CP-200901682
Log # TXNB-09081

**SUBJECT: COMANCHE PEAK NUCLEAR POWER PLANT, UNITS 3 AND 4
DOCKET NUMBERS 52-034 AND 52-035
RESPONSES TO REQUESTS FOR ADDITIONAL INFORMATION NO. 3232 AND 3762**

Response to Request for Additional Information No. 3232 (CP RAI #123)

Figure 9.4-201 UHS ESW Pump House Ventilation System Flow Diagram

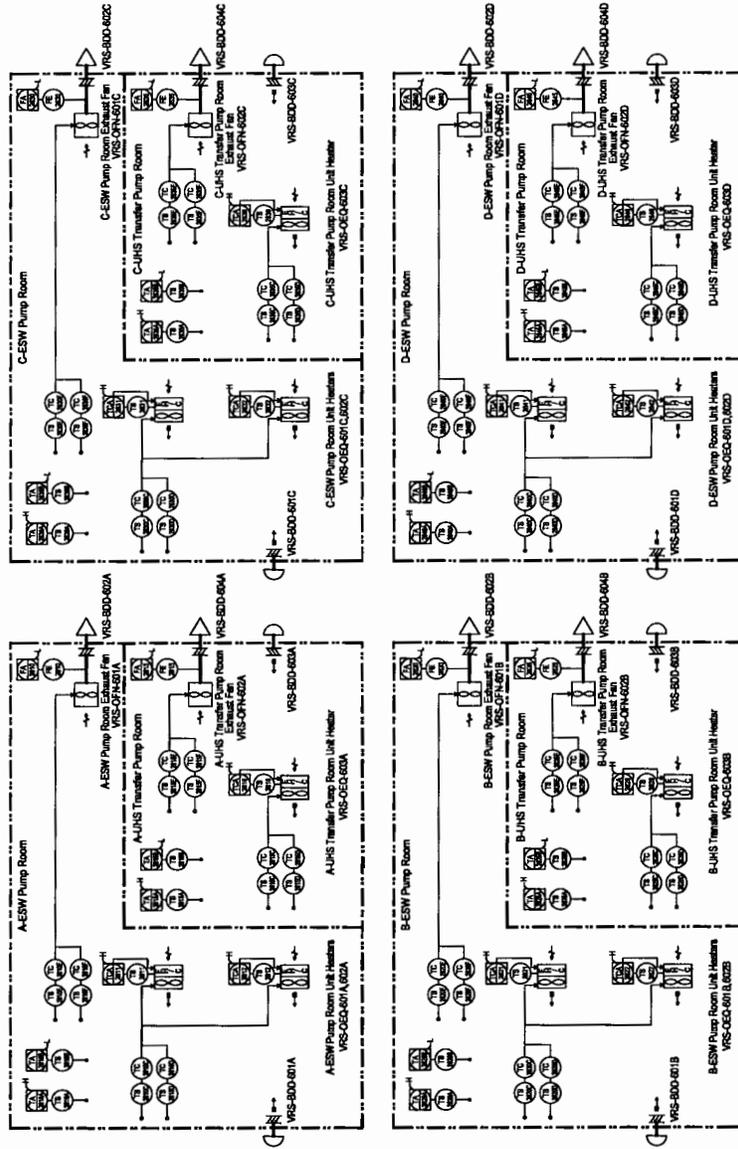
The NRC staff found that COL Figure 9.4-201 "UHS ESW Pump House Ventilation System Flow Diagram" of the applicant's FSAR does not indicate seismic classification of the components of the UHS ESW Pump House Ventilation System. Items 2.A and B of Section III "Review Procedures of SRP 9.4.5 indicates that the piping and instrumentation diagrams (P&IDs) should designate the seismic classifications of components and demarcate division between classifications.

Please provide P&IDs that designate the seismic classifications of components and demarcate division between classifications

In addition, the NRC staff found that it appears from review of Figure 9.4-201 that heating ventilation and air conditioning (HVAC) duct work exists on both sides of the back draft dampers of the air outlets and on the upstream side of the back draft dampers of the air intakes of each room's ventilation system. The staff found that Table 3.2-201 "Classification of Site-Specific Mechanical and Fluid Systems, Components, and Equipment" does not list "ducts" or ducting as a system component for UHS ESW Pump House Ventilation System. Please explain why Table 3.2-201 does not list ducts or ducting as a system component.

Therefore, with respect to GDC 4 and SRP section 3.5.2 the NRC staff notes that conventional air intake and air outlet symbols (per US-APWR DCD Figure 1.7-4 "Legend for Piping and Instrumentation Diagrams of HVAC System") are displayed on COL Figure 9.4-201. The NRC staff also notes that tornado dampers are provided a unique symbol in the legend of DCD Figure 1.7-4. This unique symbol is not employed on COL Figure 9.4-201.

It is not clear to the NRC staff from its review of the applicant's FSAR Chapters 3 and 9 how these air intakes and air outlets are protected from tornado generated missiles. The staff could find no discussion of this design basis commitment in its review of FSAR Chapter 3 "Design of Structures, Systems, Components, And Equipment". The NRC staff requests that the applicant clarify the FSAR appropriately with information designating tornado dampers.

the staff concludes that all the instrumentation (e.g. TS, TC, FE) and alarms displayed on Figure 9.4-201 "UHS ESW Pump House Ventilation System Flow Diagram" is equipment class 3 and seismic category I. The staff found the following inconsistencies for this homogeneous grouping of instrumentation:

- COL FSAR subsection 9.4.5.5.6 does not list TS and TCA instruments/alarms for the unit heaters contained in the ESW Pump Room or the UHS Transfer Pump Room
- Not all the instrumentation displayed on Figure 9.4-201 appears in Table 3D-201 "Site-Specific Environmental Qualification Equipment List". FSAR subsection 3.11.1.1 reads "This table (i.e. Table 3D-201) lists information on site specific safety-related or important to safety equipment." In addition, Table 3D-201 does not list the tornado resistant back draft dampers for the ESW Pump Rooms and UHS Transfer Pump Rooms (e.g. VRS-BDD-603A, VRS-BDD-601A)
- COL FSAR Chapter 7 "Instrumentation and Controls" does not include any reference to the homogeneous grouping of instruments displayed on Figure 9.4-201. Most of these instruments, if not all, are safety-related.

1. The UHS ESW Pump House Ventilation System contains no ductwork. The damper is mounted in the seismic category I wall opening and the fan is mounted on the seismic category I wall of each independent UHS ESW pump house. All ventilation system equipment and components are classified as equipment class 3, seismic category I. There is no seismic classification break needed. A note has been added to FSAR Figure 9.4-201 stating that all UHS ESW Pump House Ventilation System equipment and components (fans, heaters, dampers) are seismic category I.

2. The UHS ESW Pump House Ventilation System contains no ductwork, as indicated by revised FSAR Figure 9.4-201.
3. The UHS ESW Pump Houses each contain a wet-pipe sprinkler system, hose station and smoke detection system. These fire protection components are classified as non-safety-related. With the exception of standpipes supplying manual hose stations, these fire protection components are seismically supported such that their failure during a design basis seismic event will not damage any of the safety-related equipment in the areas. As discussed in DCD Subsection 9.5.1.2.4, the standpipe systems supplying hose stations are designed to remain functional under safe shutdown earthquake loadings for manual fire suppression in areas containing equipment required for safe-shutdown.

Revised FSAR Figure 9.4-201 is attached to show that the exhaust fans are wall mounted and the backdraft dampers are located in the wall openings. No duct work is installed in the system. A note has been added stating that ventilation system equipment and components (fans, heaters, dampers) are seismic category I.

1. All fans, dampers and heaters in this sheet are designated in accordance with Seismic Category I.
2. Backdraft dampers are mounted in the wall opening.
3. No system ductwork is installed.
4. Exhaust fans are wall-mounted.

Backdraft dampers are mounted in the wall opening on the outside air intakes and the exhaust outlets as shown in FSAR Figure 9.4-201. These backdraft dampers perform a function similar to tornado dampers. The safety-related design basis contained in the seventh bullet of FSAR Subsection 9.4.5.3.6 states that the backdraft dampers are capable of withstanding the affects of tornado wind and atmospheric differential pressure loading. Therefore, separate tornado dampers are not required.

1. FSAR Table 9.4-203 has been added to provide the FMEA for the UHS ESW Pump House Ventilation System.
- 2a. The safety-related temperature switches associated with the UHS ESW Pump House Ventilation System are identified in items 33 through 64 of FSAR Table 3D-201. The safety function of these switches is to initiate the ESW and UHS transfer pump room exhaust fans and heaters. As stated in the response to RAI No. 3532 (CP RAI No. 83) Question 14.03.07-27 attached to Luminant letter TXNB-09065 dated November 13, 2009 (ML093210468), the remaining alarms, displays, and controls shown on FSAR Figure 9.4-201 are not relied upon for safety-related operation of the UHS ESW Pump House Ventilation System. The description in FSAR Subsection 9.4.5.5.6 has been revised to be consistent with FSAR Table 3D-201.

Figure 9.2.5-20 Ultimate Heat Sink System Piping and Instrumentation Diagram (Sheet 2 of 2)

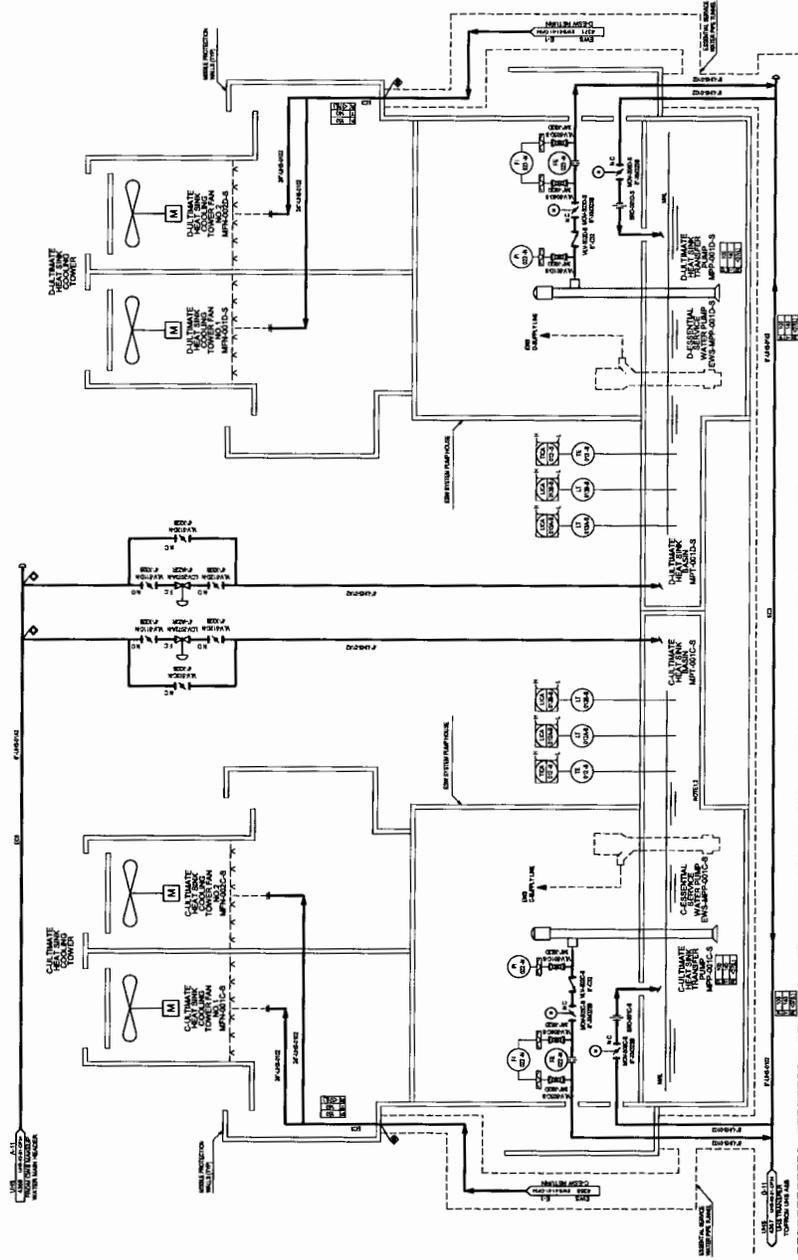
- FSAR Figures 1.2-206, Section E1-E1, and 1.2-210, Section D2-D2, show the transfer pump discharge pipe going into different essential service water (ESW) tunnel compartments; whereas, the description in FSAR Section 9.2.5 and Figure 9.2.5-201 indicate that there is only one common transfer pump discharge/transfer pipe such that only one of the compartments would be used.

- As stated in the response to the first bullet item of Question 9.02.05-1 of this RAI, FSAR Figures 9.2.1-1R and 9.2.5-201 include information to identify local instrumentation and instrumentation that provides input to the MCR (via PSMS or PCMS). The attached COLA Part 10, Appendix A.1 Tables A.1-2 and A.1-3, as revised per response to RAI 3293 (CP RAI 81), Questions 14.03.07-5 and 14.03.07-7, respectively show: (1) the site-specific UHS and ESWS equipment characteristics (including remotely operated valves and active safety functions of equipment); and (2) alarms, displays and controls in the MCR and remote shutdown console (RSC).

- A common discharge header is provided for all four UHS transfer pumps. A discharge pipe from each transfer pump penetrates its basin wall and is connected to the common header. The discharge header running the entire length of the cooling towers is located in the ESW pipe tunnels adjacent to the UHS basins and penetrates the tunnel wall. FSAR figure 9.2.5-201 is a piping and instrumentation diagram and not all structural details are shown on this drawing. FSAR Subsection 9.2.5 is revised to clarify the description.
